Technical Peer Review – District Wide Regulation Model, Version 2 Southwest Florida Water Management District

Peer Review Panel

In the summer of 2008, the District initiated a voluntary peer review of DWRM2. The purpose of the peer review was to provide a critical, constructive, technical evaluation of DWRM2 and the FTMR procedure. The peer review was performed to determine the model's capacity to accurately simulate impacts to water resources of the District. Because DWRM2 was developed specifically for use in FTMR applications for water-use permit applications, the panel focused on the model's capacity to accurately simulate drawdown and changes in surface-water boundary condition flows at a combination of regional and FTMR scales instead of the model's capacity to simulate absolute water-level elevations. Specific peer review objectives stated in the scope of work (SWFWMD, 2008) for the peer review include determining whether DWRM2 is:

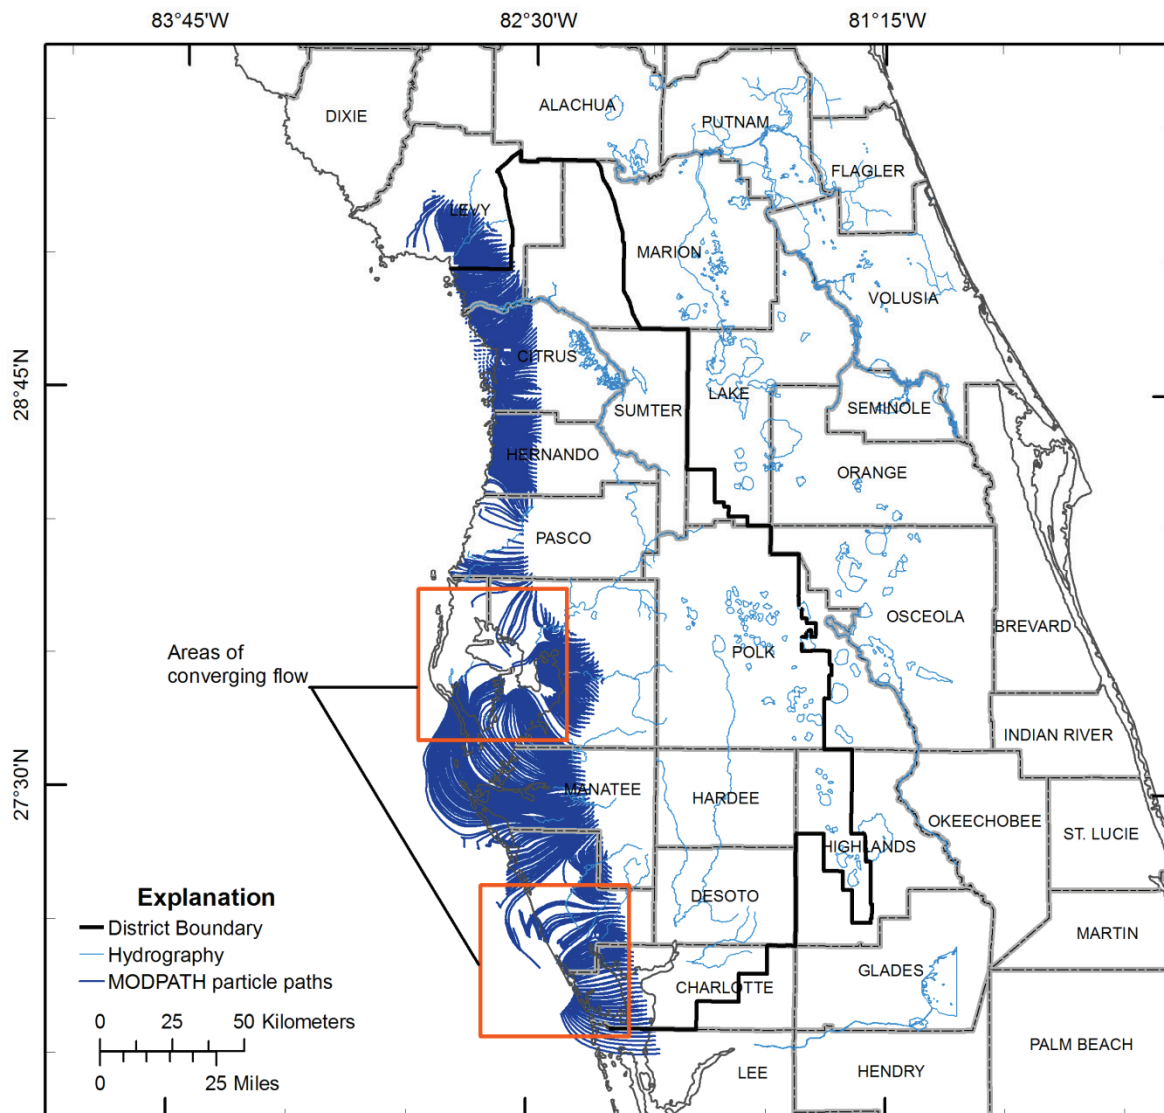
Forward particle paths in coastal areas of the model for pre-development conditions are shown in Figure 26. Particle paths in the vicinity of Tampa Bay and the SWUCA do not appear to be consistent with expected flow directions; paths appear to be adversely affected by UFA water levels that are lower in these areas than in surrounding areas as a result of differences in leakance parameters or equivalent freshwater heads (see Figure 13).

It is not reasonable to use particle tracking analysis with DWRM2 to evaluate changes in the position of the freshwater/saltwater interface resulting from ground-water withdrawals. Large boundary condition flows in coastal areas and use of equivalent freshwater constant heads offshore appreciably contribute to the limitations of the application of particle tracking analysis. It is possible that model parameters and boundary conditions could be revised to simulate more realistic particle tracks in coastal areas. Because use of equivalent freshwater heads in MODFLOW simulations does not account for buoyancy effects in the ground-water flow equation solved during simulation, inherent limitations to accurately simulate flow in coastal areas always will result.

Figure 27 Areas where DWRM2 and FTMR model water budget comparisons were performed.

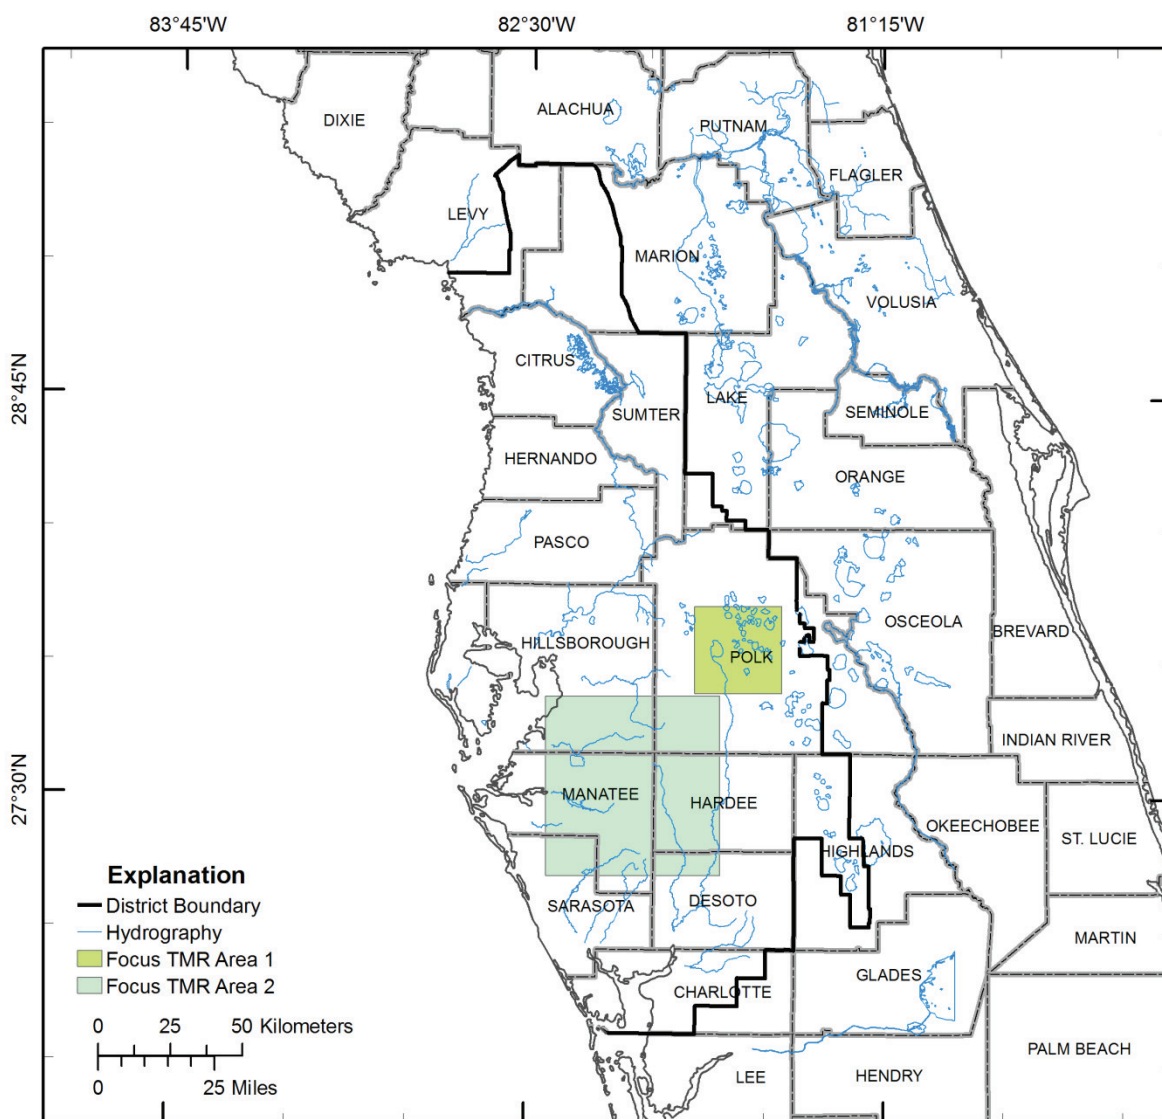
Water budgets were calculated for two focus areas of DWRM2 to evaluate the FTMR process (Figure 27). Comparison of water budgets for DWRM2 and two FTMR models is summarized in Table 4 and 5. DWRM2 water budgets were calculated using functionality available in GWV. FTMR water budgets are based on water-budget information in the MODFLOW listing (*.lst) file for the FTMR models. Water budgets were calculated for DWRM2 cells within the constant-head boundary cells in the FTMR models. DWRM2 water budgets were calculated for these areas because MODFLOW water-budgets exclude boundary conditions (for example, recharge, wells, rivers, and drains) in constant-head cells. Water budgets were compared for 2001 conditions (stress period 2) in both the regional DWRM2 and local FTMR models.

Differences in water-budget components between DWRM2 and the FTMR models are greater than expected; it is expected that ground-water withdrawals would be identical and other water budget components would be within $\pm 10\%$ of each other. Significant differences were observed between river, drain, and boundary condition flow in the DWRM2 and FTMR models; if differences in boundary condition flow rates exceed differences in proposed ground-water withdrawals it is questionable how reliable FTMR models will be in evaluating ground-water impacts. The overall FTMR water budget for Area 1 (Table 4) was closer to the DWRM2 water budget than for Area 2 (Table 5), although there were significant differences in river and aquifer-drain flow for Area 1.

Regardless of whether the FTMR approach is revised, a water-budget analysis of the regional and FTMR model similar to the ones presented above should be included in the standard report generated as part of the FTMR process. A water-budget analysis will give users of DWRM2 the ability to evaluate if FTMR results are reasonable and adequate. For example, the user may find that differences in boundary condition flow rates are more than 10%. This result may indicate that the extent of the FTMR model should be expanded. The District should define general guidelines for acceptable differences in water-budget terms between the DWRM2 and FTMR models.
